3B Containment Hydrodynamic Loads

The information in this appendix of the reference ABWR DCD, including all subsections, tables, and figures, is incorporated by reference with the following departures.

STD DEP 3B-2 (Table 3B-1, Figures 3B-12 and 3B-13)

STD DEP Admin (Figures , 3B-21, 3B-24, 3B-26)

Figure 3B-12 Time History of Air Bubble Pressure

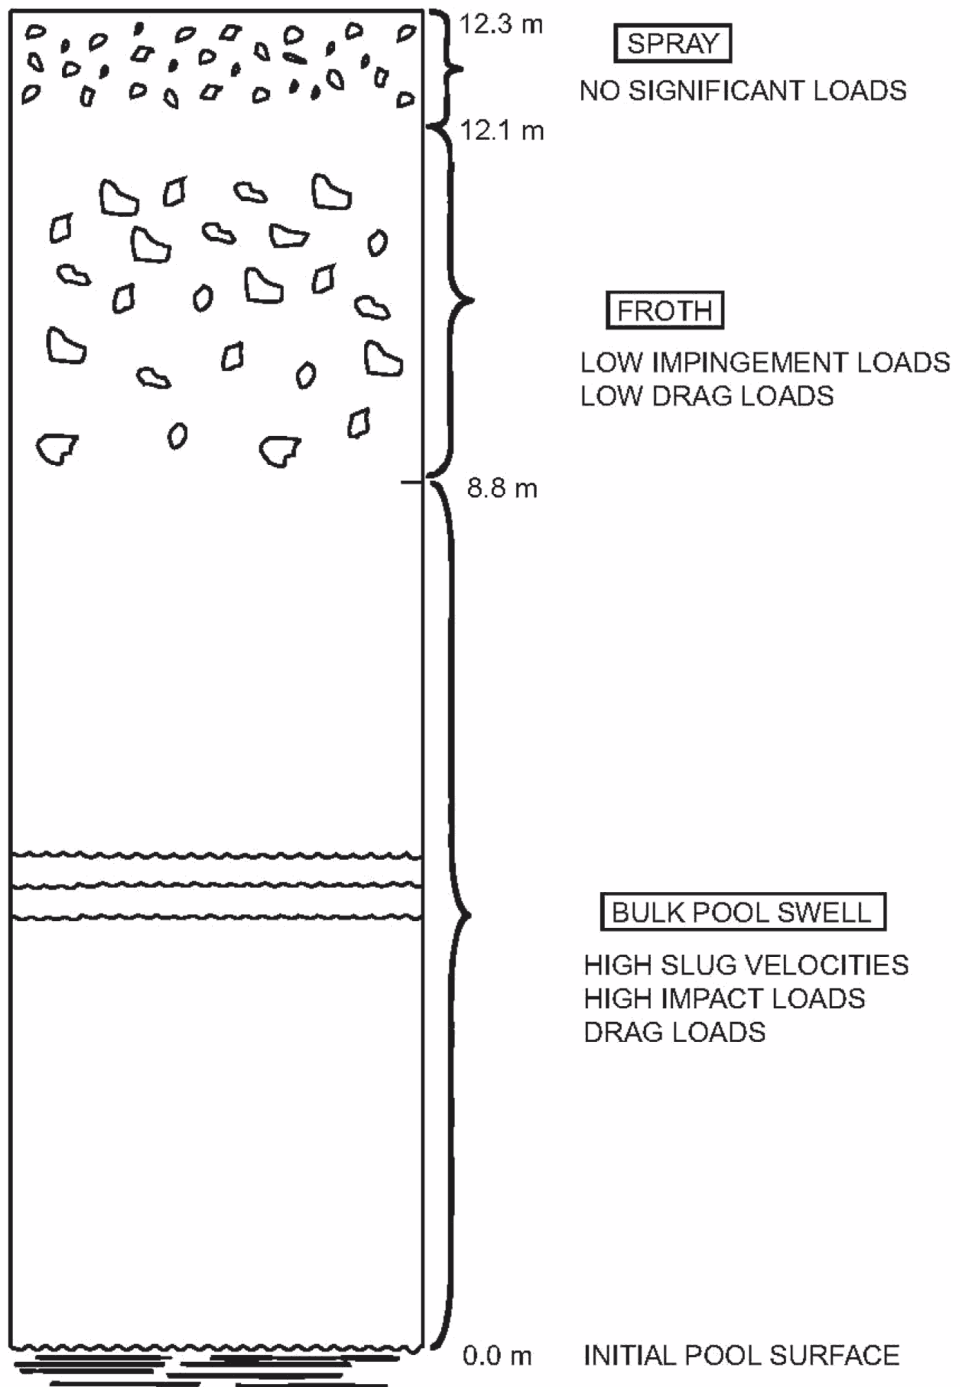
ABWR pool swell response calculations to quantify pool swell loads were based on a simplified, one dimensional analytical model. The model was qualified against test data from the Pressure Suppression Test Facility (PSTF) for a 1/3- scaled Mark III pressure suppression system geometry. The methodology is similar to, ~~same as that reviewed and accepted by the staff (NEDE-21544P/NUREG-0808) for application to Mark II plants. This analytical model was qualified against Mark II full scale test data.~~ The ABWR pressure suppression system design is similar to the Mark III design. The main difference is the smaller gas space above the suppression pool in the ABWR. This difference is accounted for in the analytical model for the pressure suppression system. ~~utilizes a confined wetwell airspace similar to that in Mark II design, but its vent system design is quite different than that in Mark II design. The ABWR vent system design utilizes horizontal vents similar to that in Mark III design. Therefore, recognizing this difference in vent system design, additional studies comparing model against Mark III horizontal vent test data were performed to assure adequacy of the model for application to ABWR.~~

Test data used to qualify the analytic model was taken from 1/3-scale tests for a Mark III geometry. The submergence to pool width ratio was representative of conditions in an ABWR. The GOTHIC code was used to model the Mark III tests. The model was designed to bound the test data. The test data used in the model comparison, and the modeling approach, are fully described in Reference 3B-17. Model input/assumptions used in predicting Mark III test data for model comparison were the same as prescribed in NEDE 21544P. Mark III horizontal vent system features were modeled in the following manner: The major modeling assumptions were:

Description	Value
1. Air bubble pressure (maximum)	133.37 kPaG 195 kPaG
2. Pool swell velocity (maximum)	10.9 m/s
3. Wetwell airspace pressur (maximum)	107.87 kPaG 146 kPaG
4. Pool swell height (maximum)	7m 8.8m

Figure 3B-13 Schematic of the Pool Swell Phenomenon

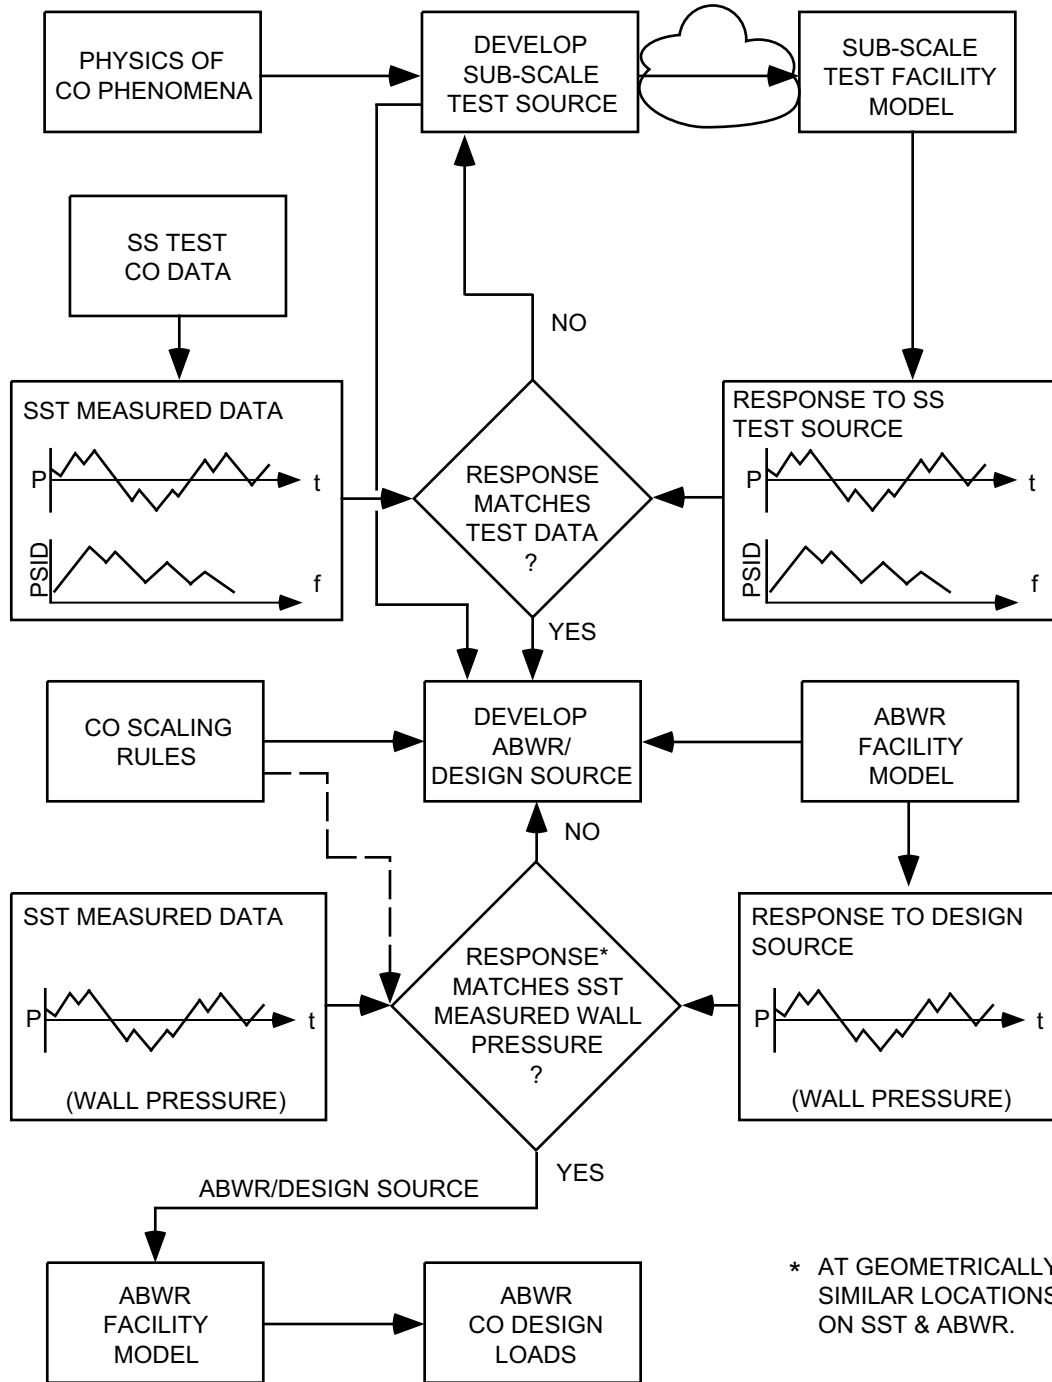
Structures located at elevations between the ~~7m~~8.8m and ~~40.3m~~12.1m will be subjected to froth impact loading. This is based on the assumption that bubble breakthrough (i.e., where the air bubbles penetrate the rising pool surface) occurs at ~~7m~~8.8m height, and the resulting froth swells to a height of 3.3m. ~~This froth swell height is the same as that defined for Mark III containment design and this.~~ This is considered to be conservative for the ABWR design. Because of substantially smaller wetwell gas space volume (about 1/5th of the Mark III design), the ABWR containment is expected to experience a froth swell height substantially lower than the Mark III design. The wetwell gas space is compressed by the rising liquid slug during pool swell, and the resulting increase in the wetwell gas space pressure will decelerate the liquid slug before the bubble break-through process begins. The load calculation methodology will be based on that approved for the Mark III containment (NUREG-0978).

As shown in Figure 3B-13 the gas space above the ~~40.3 m~~12.1m elevation will be exposed to spray condition ~~including~~ which is expected to induce no significant loads on structures in that region.

Structures located between 0 and ~~7m~~8.8m above the initial surface will be subjected to impact load by an intact water ligament, where the ~~7m~~8.8m value corresponds to the calculated maximum pool swell height. The load calculation methodology will be based on that approved for Mark II and Mark III containments (NUREG-0487 and NUREG-0978).
